NL-17-035

SUBJECT: Proposed License Amendment Regarding Connection of Non-Seismic Boric Acid Recovery System to the Refueling Water Storage Tank
Indian Point Unit No. 2
Docket No. 50-247
License No. DPR-26

ANALYSIS OF PROPOSED TECHNICAL SPECIFICATIONS CHANGE
REGARDING CONNECTION OF NON SEISMIC BARS
TO REFUELING WATER STORAGE TANK

INDIAN POINT 2 DRAWINGS AND CALCULATION

INCORPORATED 93-3236		7/9/00	RM	APPROVED	D.N.	E.A.L.	M.J. KIDG	1/29/95	STATION
TITLE: FLOW DIAGRAM AUXILIARY COOLANT SYSTEM -								INDIAN POINT	
LFSAR FIGURE No. 9.3-1 (SHT. 1) BY: D. BALAO CHECK: NONE NO. A227781-82								NY

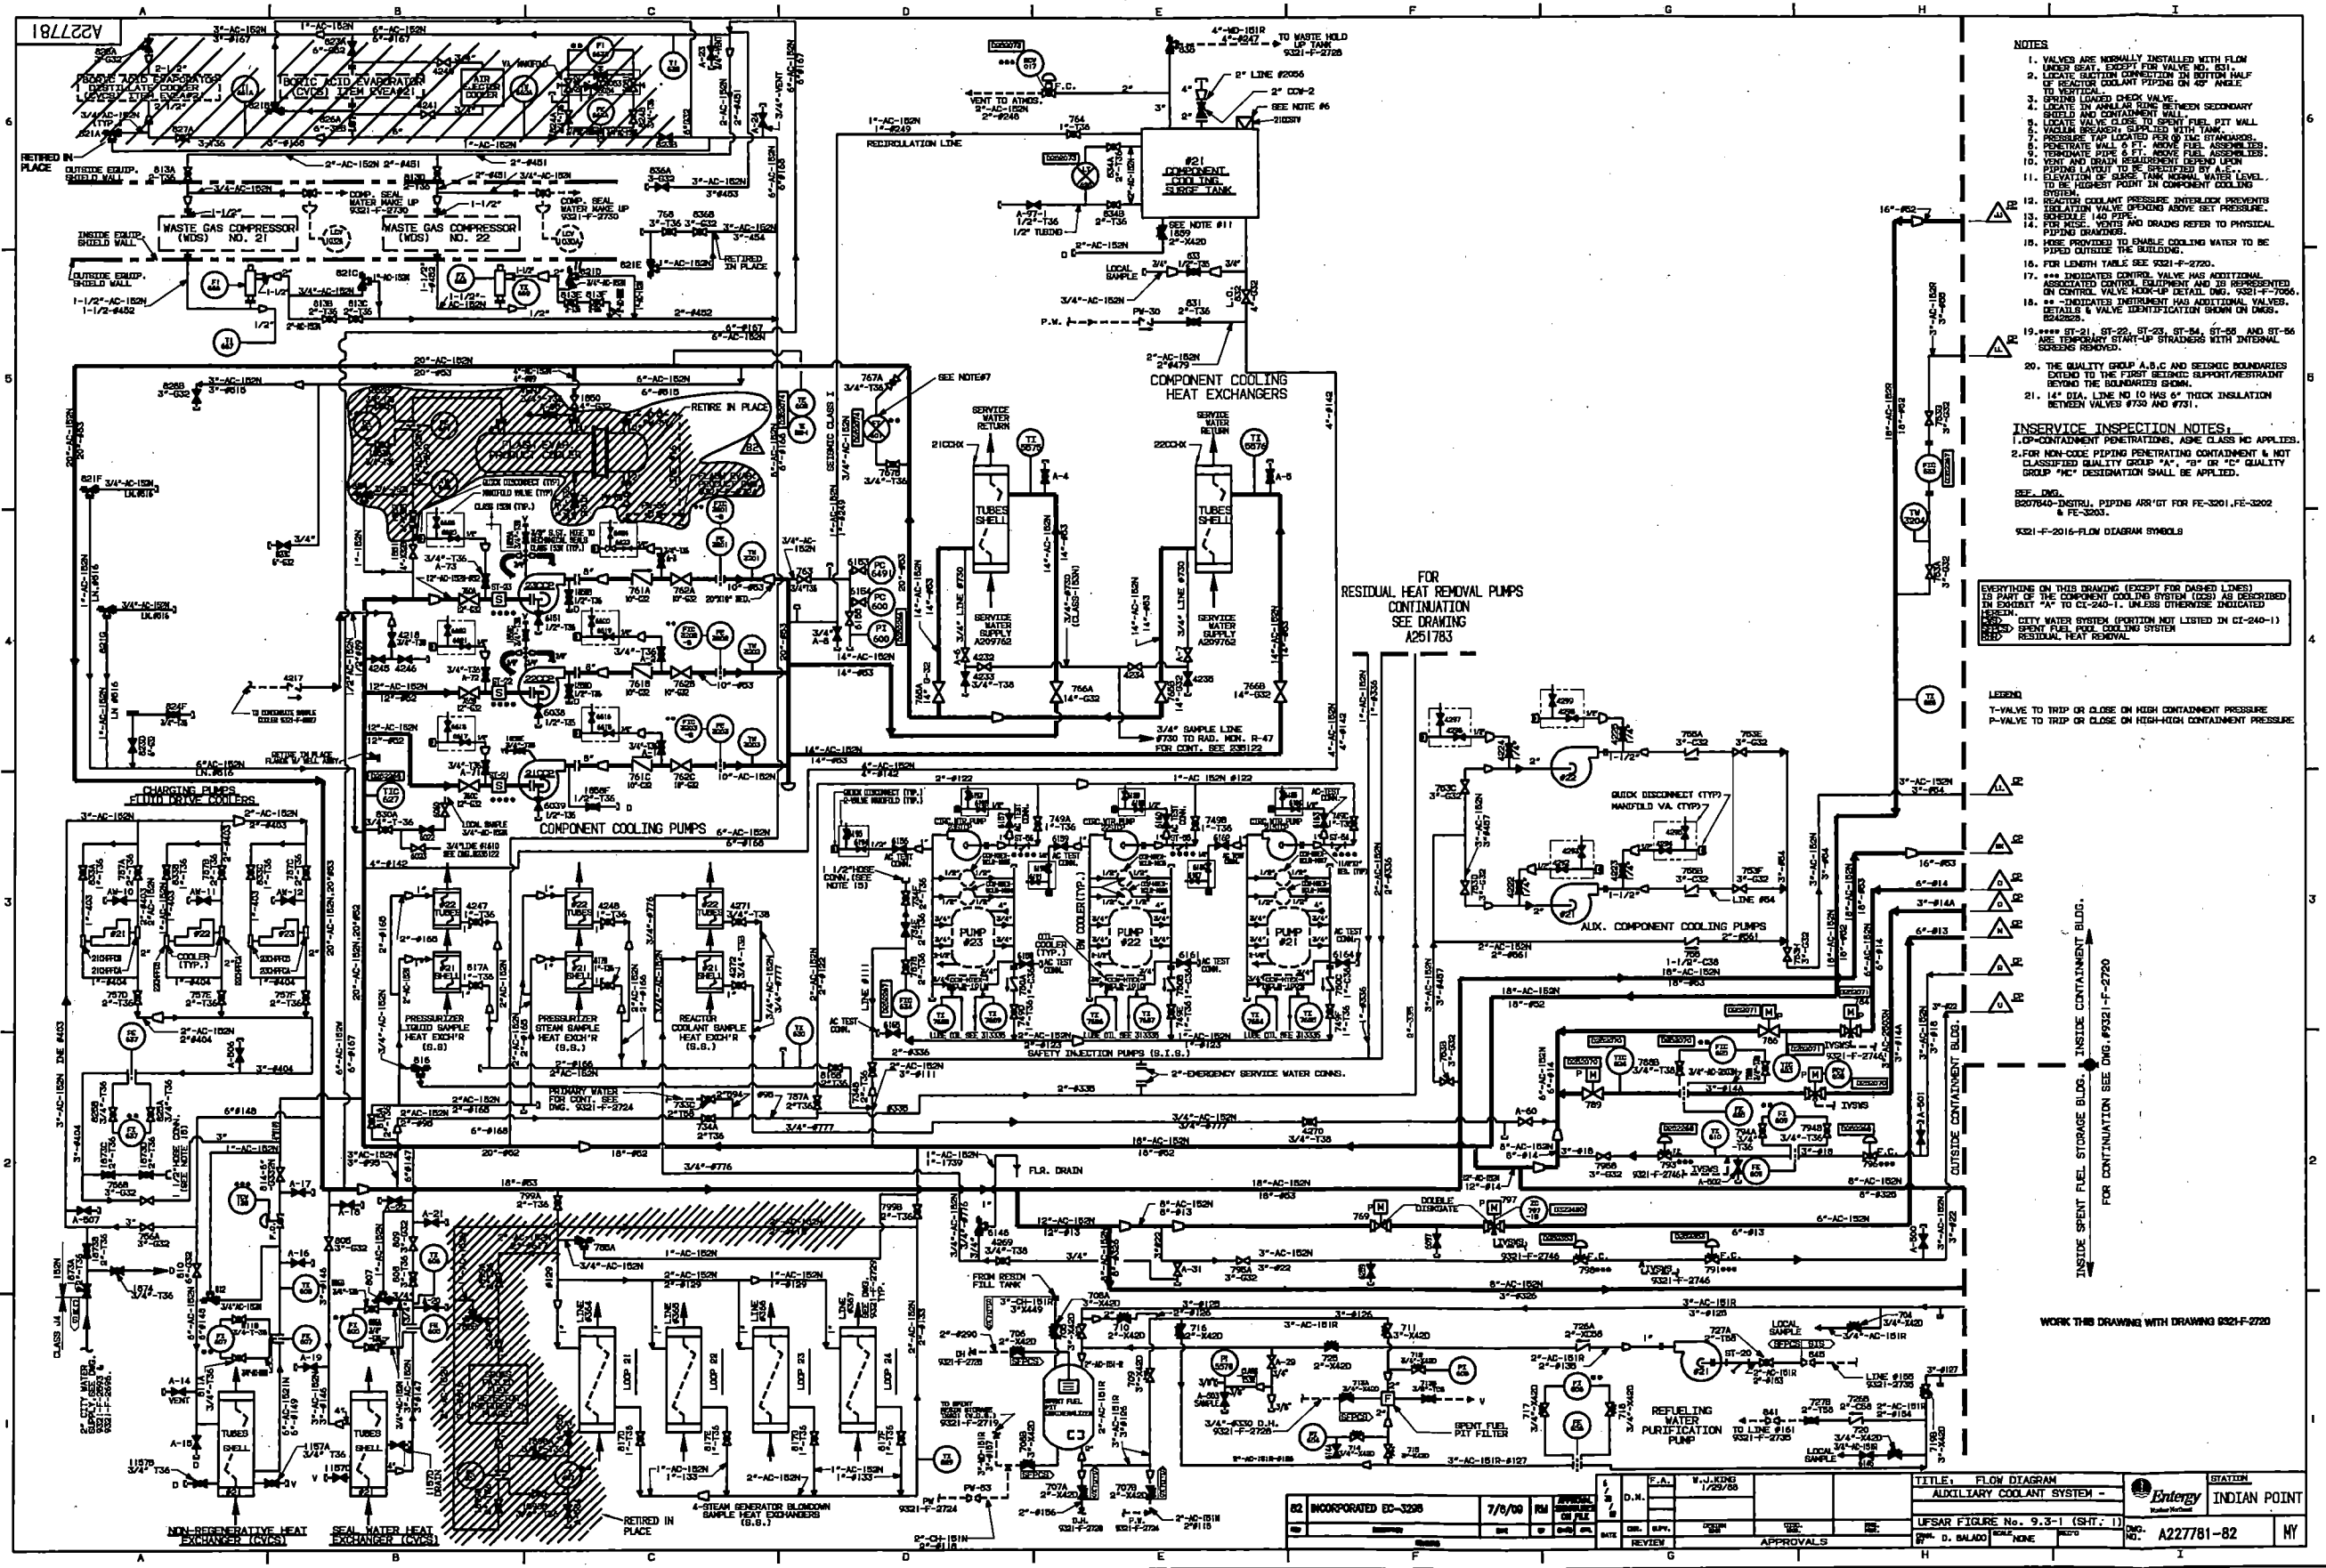
- The BARS suction line is connected to Valve 725 (see Drawing A227781, quadrant F-1 in the Enclosure) on the discharge to the Refueling Water Purification Pump (RWPP) by removing the valve bonnet and valve internals and installing a hose adapter plate.

The RWPP will take suction through manual isolation valve 845 on line 2"-AC-151R#183 which is connected to the 16 inch line from the RWST downstream of isolation valve 846. Normally closed isolation valve 845 will be opened (Drawing A227781, quadrant I-1), and the RWPP will take suction through valve 727A and discharge to valve 725 (Drawing A227781 quadrants G-1 to E-1). Flow through valve 725 adapter plate is to the non-seismic BARS since the spent fuel pit demineralizer is isolated. The flow from valve 725 is through a 2 inch hose adapter plate to the BARS which discharges to seismic line #253 upstream of valve 350. Flow will be through valve 350 and return line 3"-SI-151R#161 to the RWST. Flow would not be diverted back to the boric acid makeup system due to check valve 294 and normally closed manual valve 295 (see Drawings 9321-F-2736, quadrant E-3 and Drawing 9321-F-2735 (valve 350 only), quadrant I-4). The proposed manual action to isolate the BARS in the event of an actual or potential loss of RWST considered the following:

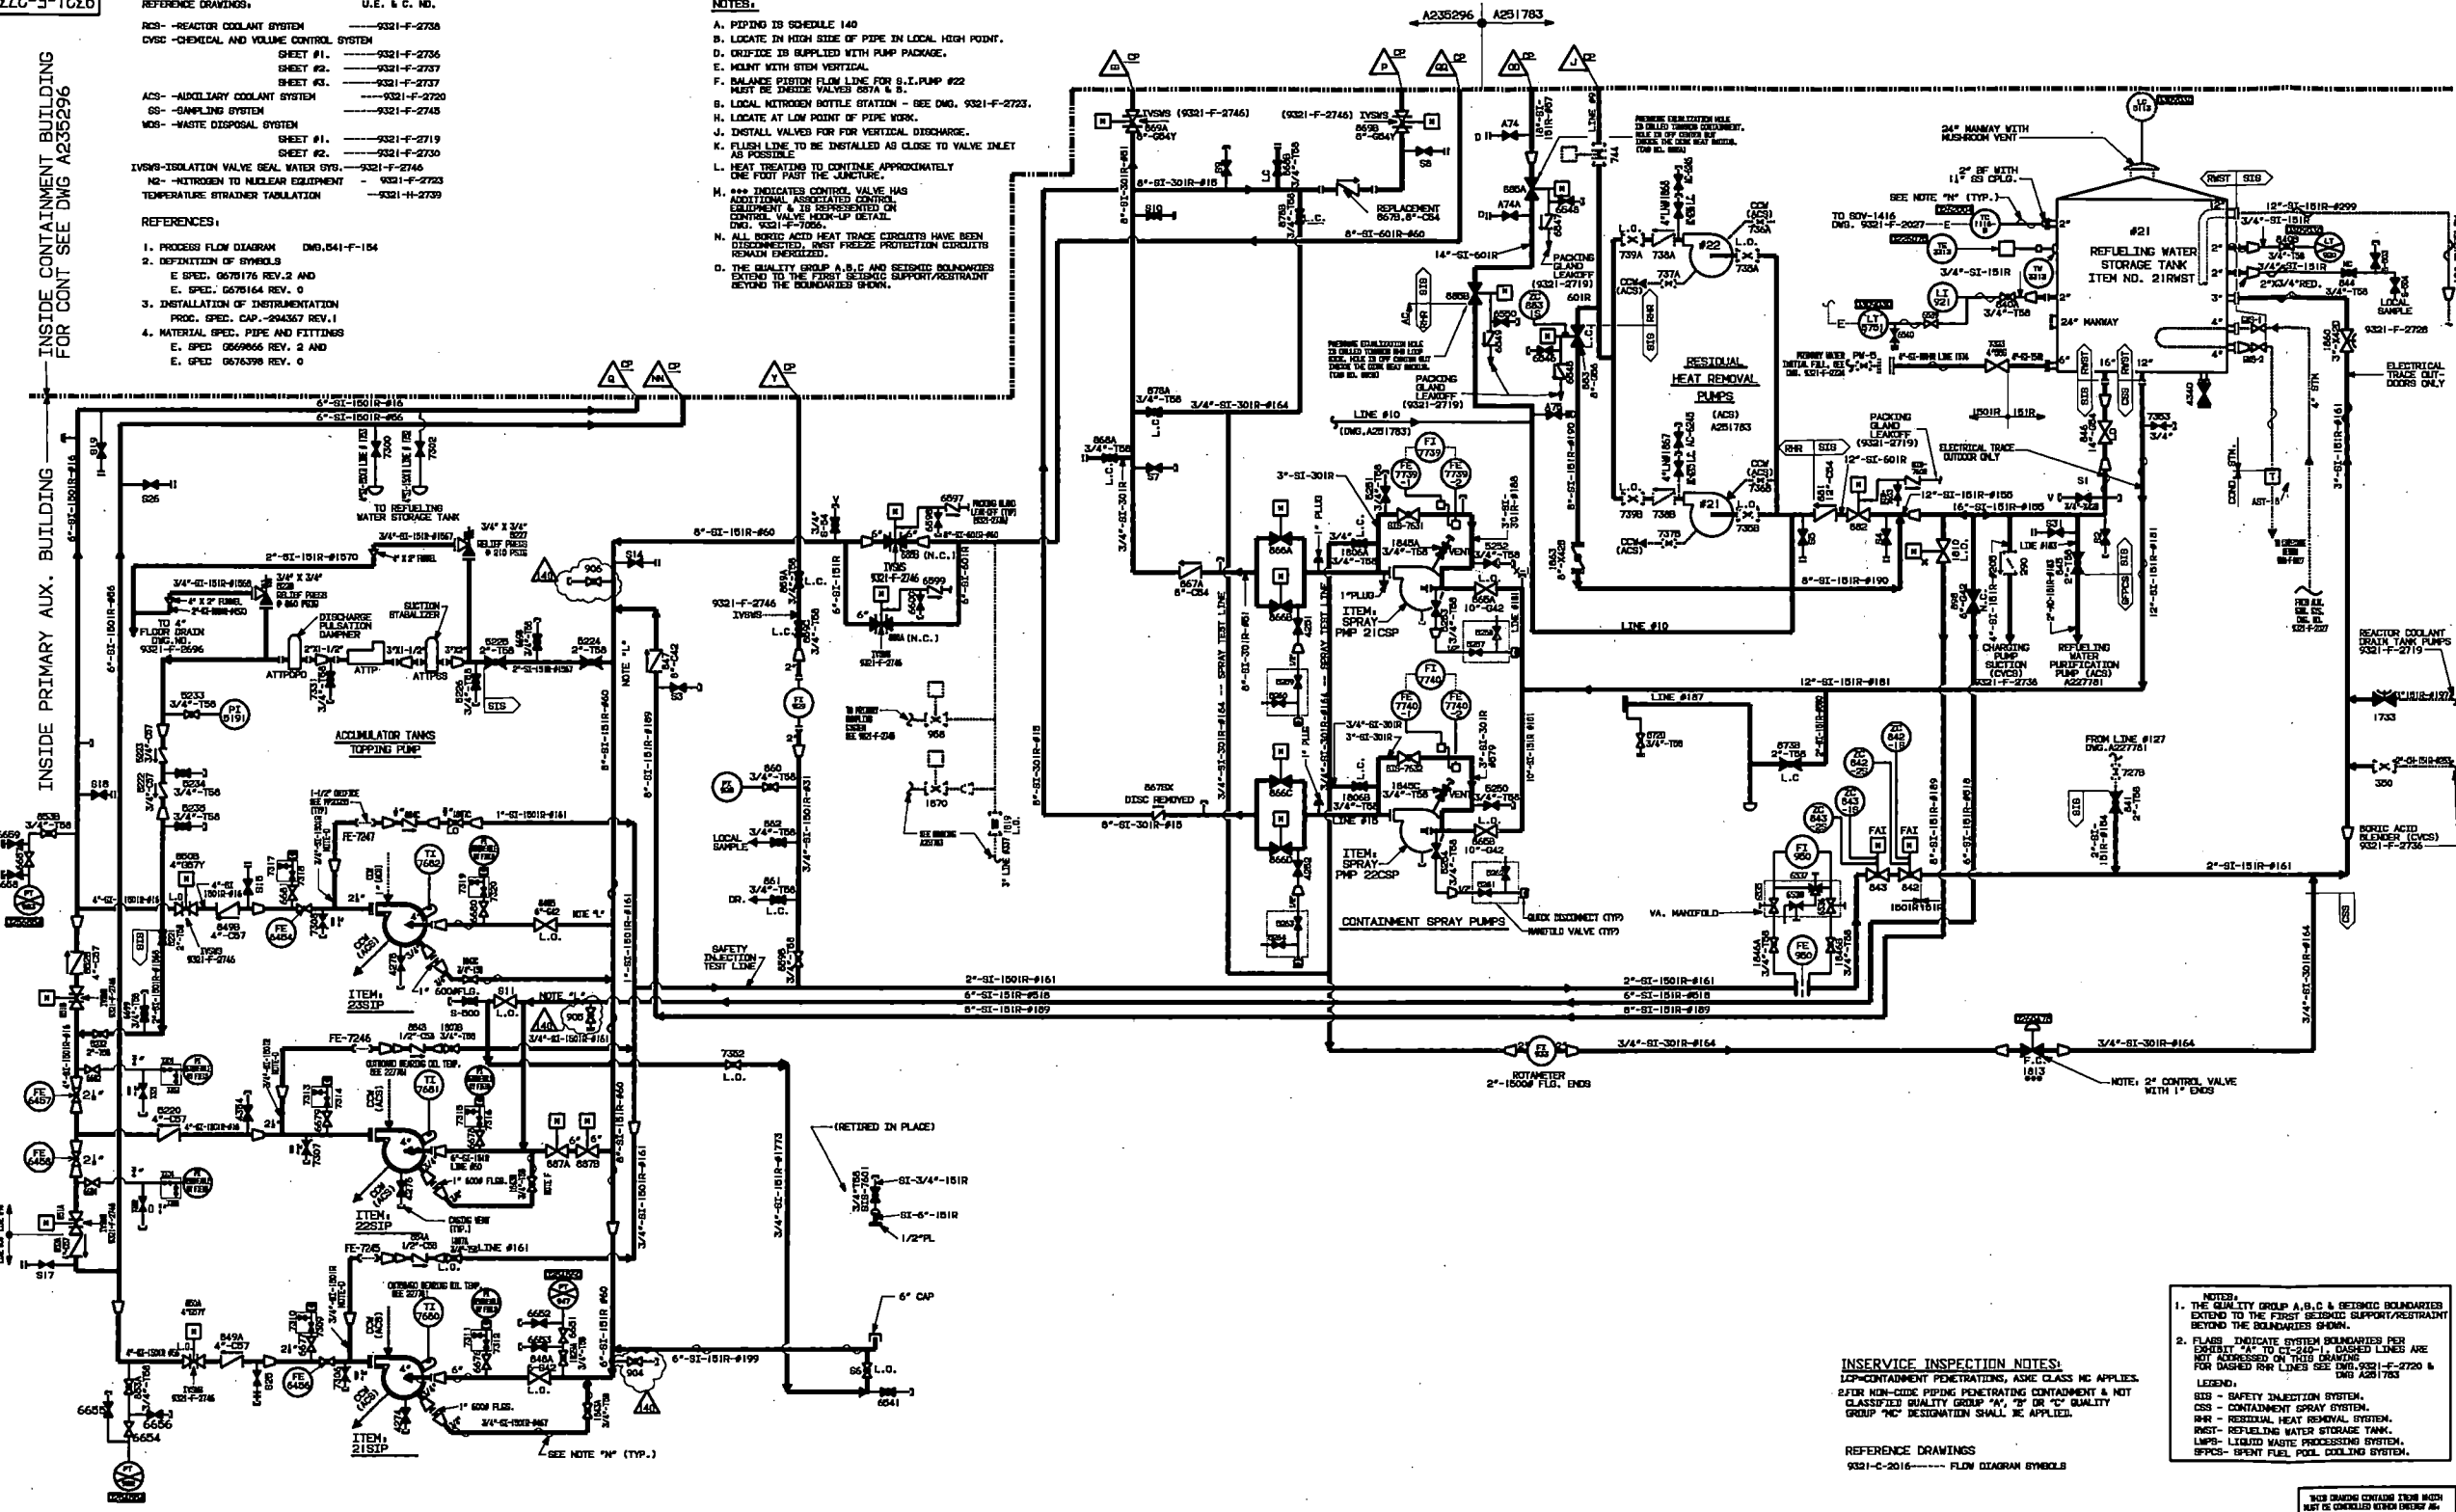
- The BARS discharge line is connected to 2 inch line #252 upstream of 2 inch valve 350 (see Drawing 9321-F-2736, quadrant E-3 and Drawing 9321-F-2735 (valve 350 only), quadrant I-4 in the Enclosure) by removing the 2"-150 psig flange and installing a hose adapter plate.
